Access Compliance Report Public Rights-of-Way (Curb Ramps)

Main Street: DAWNWOOD Cross Street: MAYBECK_LN Location: SE

ADA ID: RPRK211025114313 Ramp Type: Type 4 - Parallel Initial Pass/Fail: Fail Overall Compliance: No Severity Score: 30

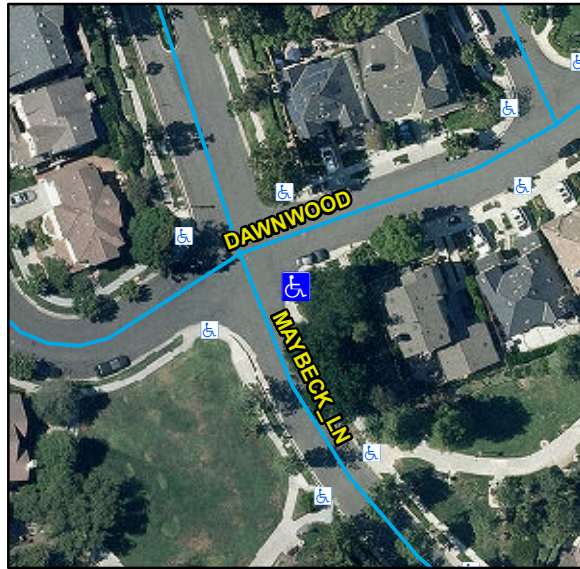
Compliance	Description	Data	Compliance	Description	Data
N/A	Ramp Length LT (in)	117	N/A	Ramp Length RT (in)	114
Yes	Ramp Width LT (in)	53	Yes	Ramp Width RT (in)	53
Yes	Ramp Run Slope LT (%)	3.2	No	Ramp Run Slope RT (%)	14.5
Yes	Ramp Cross Slope LT (%)	1	Yes	Ramp Cross Slope RT (%)	0.5
N/A	Landing Present	N/A	N/A	DWS Provided	N/A
N/A	Landing Length (in)	N/A	N/A	DWS Contrast	N/A
N/A	Landing Width (in)	N/A	N/A	DWS Length (in)	N/A
N/A	Landing Run Slope (%)	N/A	N/A	DWS Full Width	N/A
N/A	Landing Cross Slope (%)	N/A		DWS Offset Type	N/A
N/A	Landing Movement Obstructed?	N/A	N/A	DWS Offset Left (in)	N/A
	Landing Movement Type	N/A	N/A	DWS Offset Right (in)	N/A
N/A	Landing Shared	N/A			
N/A	Clear Space	Yes			
N/A	Clear Space To Crosswalk (in)	N/A			
N/A	Marked Crosswalk 1	No	N/A	Marked Crosswalk 2	No
	Crossing 1 Direction	N		Crossing 2 Direction	W
	Marked Crosswalk 1 Width (in)	N/A		Marked Crosswalk 2 Width (in)	N/A

Remove & Replace Curb Ramp With Two New Directional Ramps or Equivalent.

R204.3, R304.3.2, STD 1115
